Power Supply Ripple and MDI Return Loss Modifications

ANALOG DEVICES

Figure 104-7—PSE ripple voltage test fixture

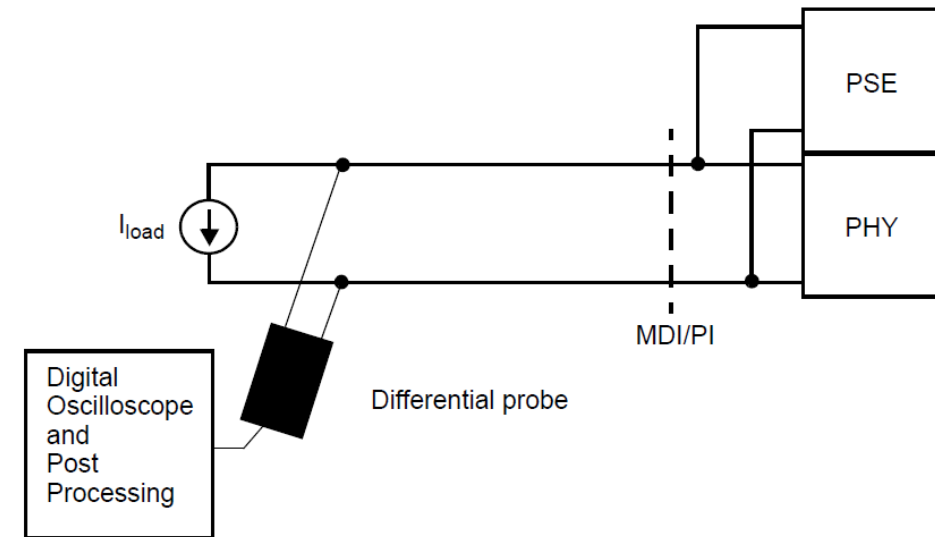
- ▶ Change the edit to clause 104.4.6.3 to separate Type F and Type B PSEs and modify the cutoff frequencies:

“A digital oscilloscope or data acquisition module with a differential probe is used to observe the voltage at the MDI/PI of the PSE device under test (DUT) as shown in Figure 104–7. The input impedance, $Z_{in}(f)$, and transfer function, $H_1(f)$, of the differential probe are specified by Equation (104–1) and Equation (104–2), respectively. When measuring the ripple voltage for a Type A or Type C PSE as specified by Table 104–4 item (4a), $f_1 = 31.8 \text{ kHz} \pm 1\%$. When measuring the ripple voltage for a Type B or Type F PSE as specified in Table 104–4 item (4a), $f_1 = 318 \text{ kHz} \pm 1\%$.”

A digital oscilloscope or data acquisition module with a differential probe is used to observe the voltage at the MDI/PI of the PSE device under test (DUT) as shown in Figure 104–7. The input impedance, $Z_{in}(f)$, and transfer function, $H_1(f)$, of the differential probe are specified by Equation (104–1) and Equation (104–2), respectively. When measuring the ripple voltage for a Type A or Type C PSE as specified by Table 104–4 item (4a), $f_1 = 31.8 \text{ kHz} \pm 1\%$. When measuring the ripple voltage for a Type B or Type F PSE as specified in Table 104–4 item (4a), $f_1 = 318 \text{ kHz} \pm 1\%$. When measuring the ripple voltage for a Type F PSE as specified in Table 104–4 item (4a), $f_1 = 318 \text{ kHz} \pm 1\%$.”

Low Frequency MDI Return Loss and Transmitter Droop

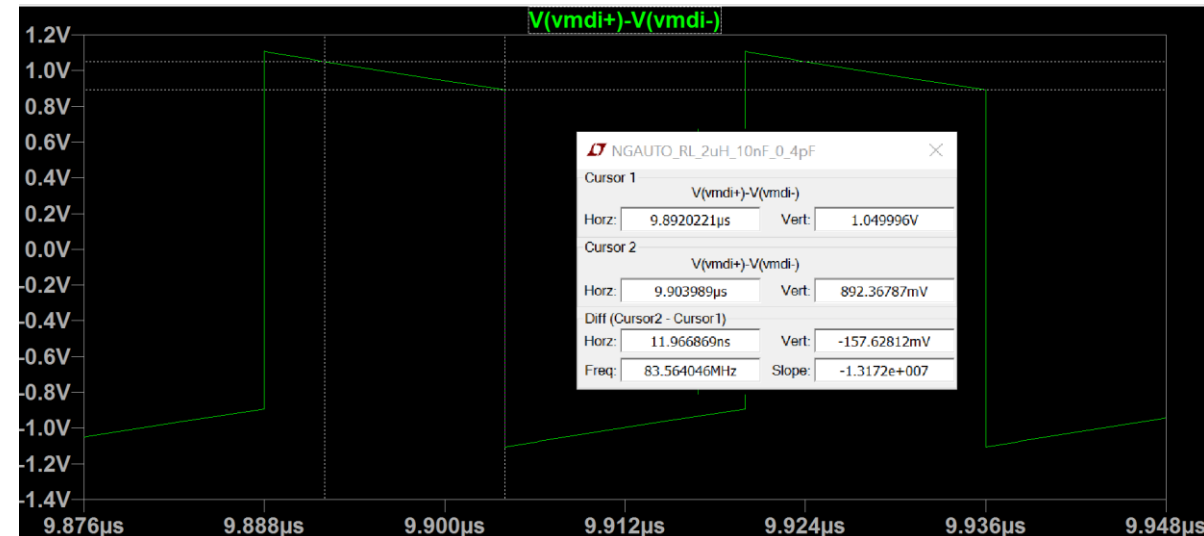
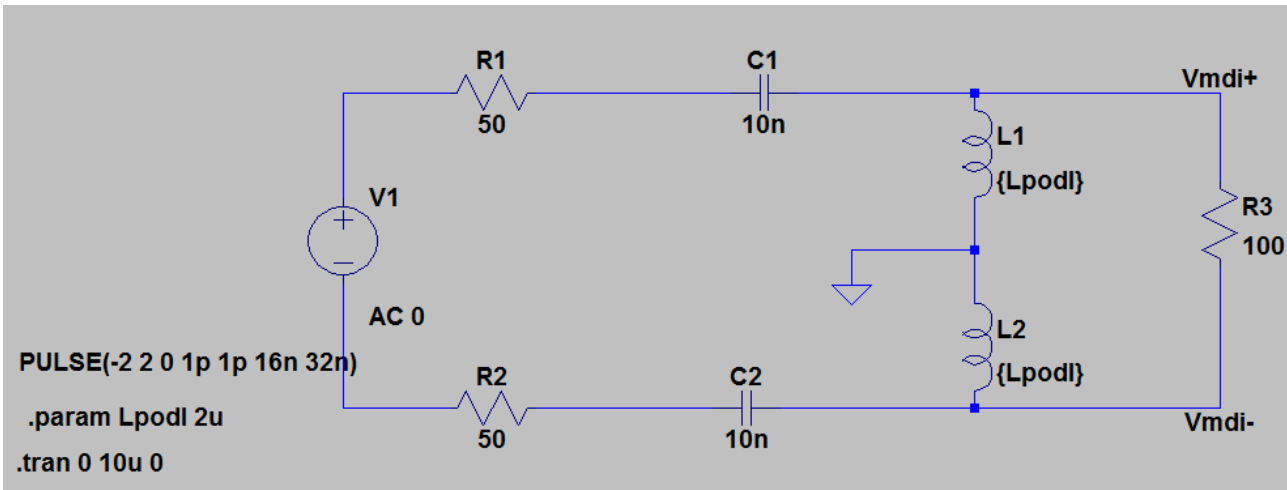
- ▶ Coupling circuit for droop simulation:
 - 2uH coupling inductor
 - 10nF coupling capacitor
- ▶ Droop calculated = 15%
 - $\text{Droop} = \frac{(1.0499 - 0.89236)V}{1.0499V} \times 100$ in 12ns
- ▶ Verify insertion loss HPF pole at 1.85Mhz
- ▶ Measure low frequency return loss for these values

Low Frequency MDI Return Loss and Transmitter Droop

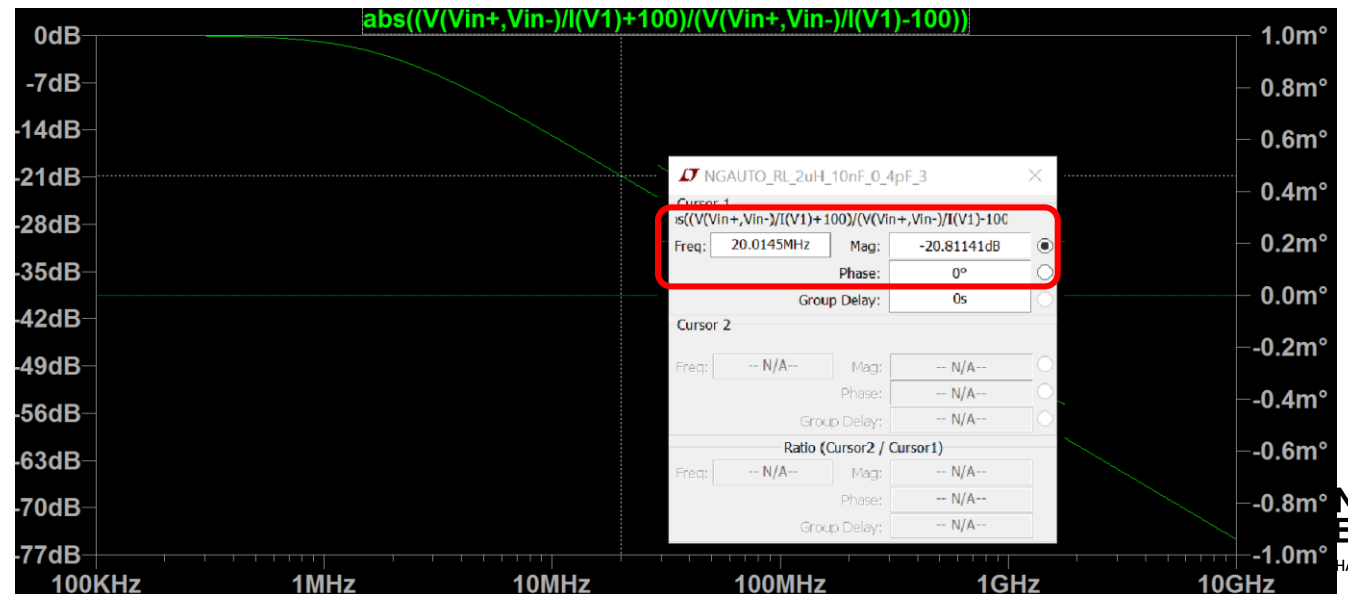
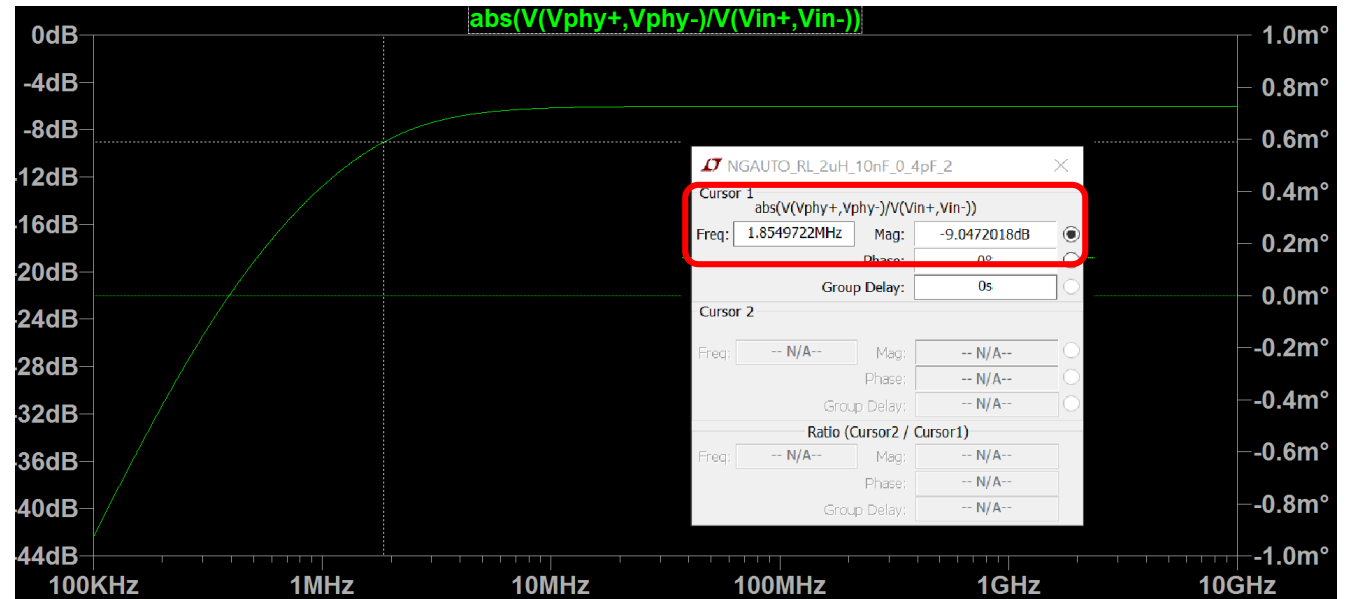
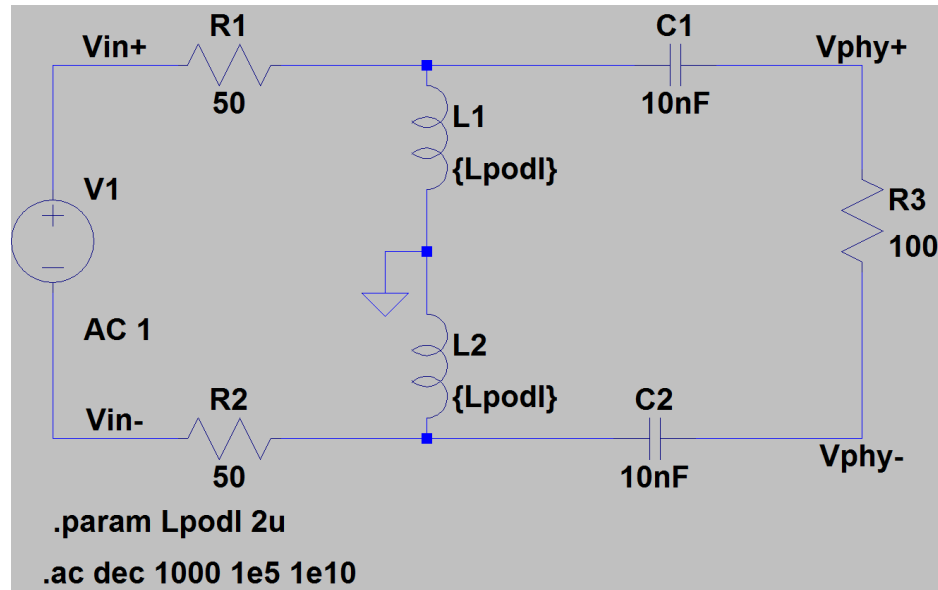
- ▶ HPF pole in insertion loss at 1.85 MHz verified
- ▶ Return Loss has a breakpoint of
 - -20dB at 20MHz
- ▶ Change the low frequency MDI return loss breakpoint to align with this

Low Frequency MDI Return Loss Text Changes

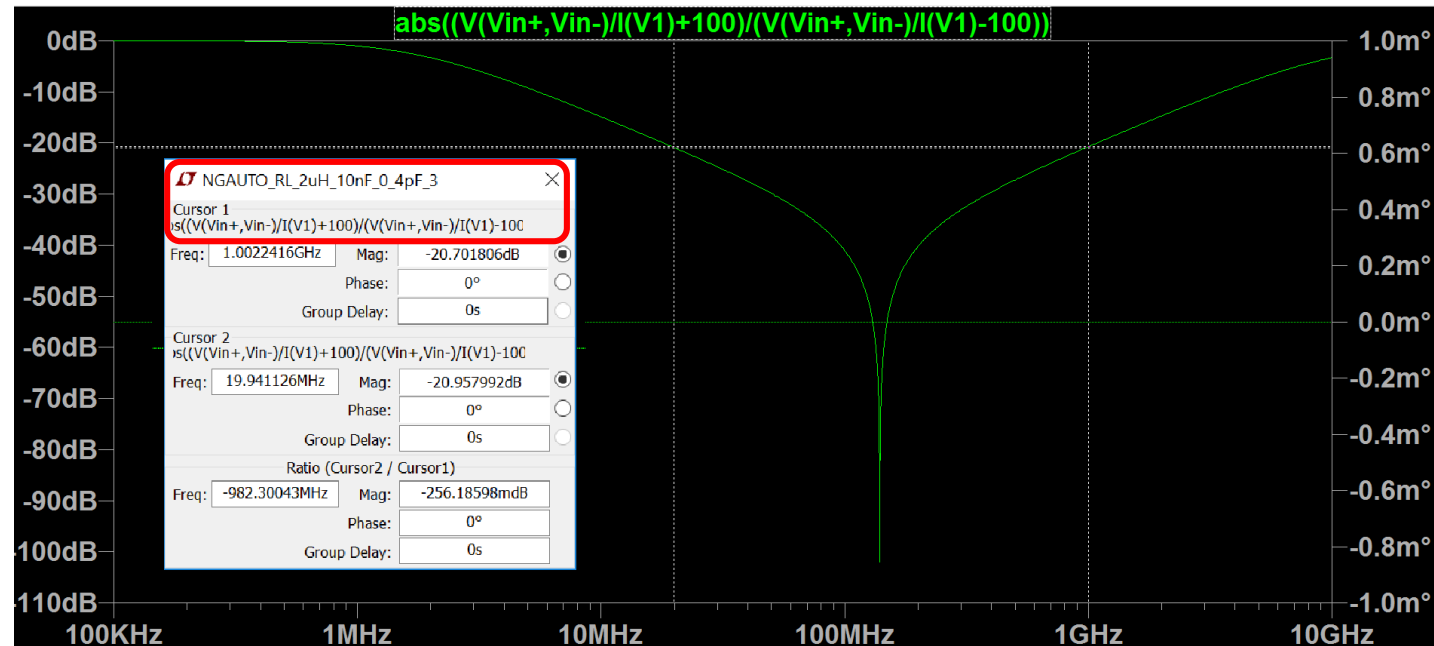
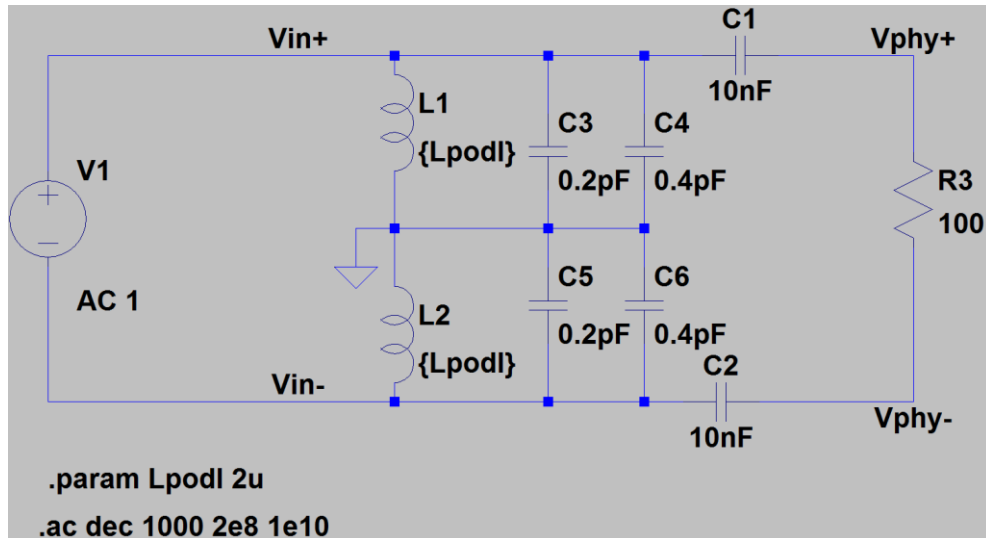
- ▶ Change the edit to clause 149.8.2.1 MDI return loss to change the low frequency breakpoint

$$MDI_Return_Loss(f) \leq \left\{ \begin{array}{ll} 20 - 20 \left(\log_{10} \frac{10}{f} \right) & 1 \leq f < 10 \\ 20 & 10 \leq f \leq 500 \\ 12 - 10 \log_{10}(f/3000) & 500 \leq f \leq 3000 \\ 12 - 20 \log_{10}(f/3000) & 3000 \leq f \leq 4000 \end{array} \right\} \text{ (dB)} \quad (149-27)$$

- **$20 - 20 \times \text{Log}_{10}\left(\frac{20}{f}\right)$** **for $2 \leq f \leq 20$**
- **20** **for $20 \leq f \leq 500$**
- $12 - 10 \times \text{Log}_{10}\left(\frac{f}{3000}\right)$ for $500 \leq f \leq 3000$
- $12 - 20 \times \text{Log}_{10}\left(\frac{f}{3000}\right)$ for $3000 \leq f \leq 4000$

All MDI Return Loss Text Changes and Comparison

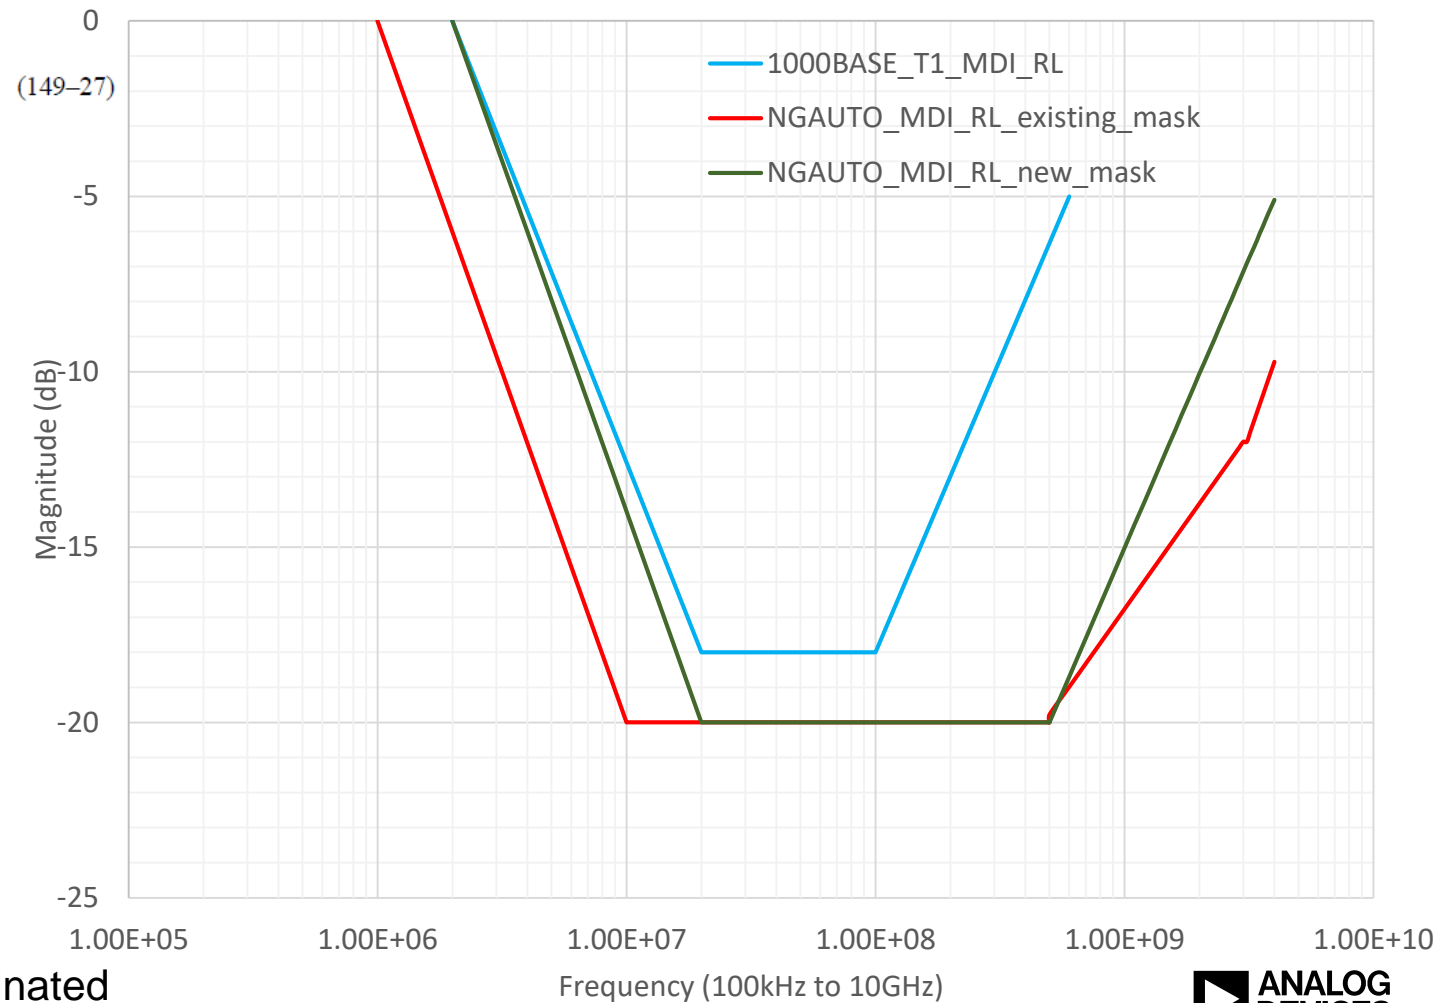
$$MDI_Return_Loss(f) \leq \begin{cases} 20 - 20 \left(\log_{10} \frac{10}{f} \right) & 1 \leq f < 10 \\ 20 & 10 \leq f \leq 500 \\ 12 - 10 \log_{10}(f/3000) & 500 \leq f \leq 3000 \\ 12 - 20 \log_{10}(f/3000) & 3000 \leq f \leq 4000 \end{cases} \text{ (dB)}$$

► Note: discontinuity in previous mask has been eliminated

- $20 - 20 \times \text{Log}_{10}\left(\frac{20}{f}\right)$ for $2 \leq f \leq 20$
- 20 for $20 \leq f \leq 500$
- $20 - 16.5 \times \text{Log}_{10}\left(\frac{f}{500}\right)$ for $500 \leq f \leq 4000$
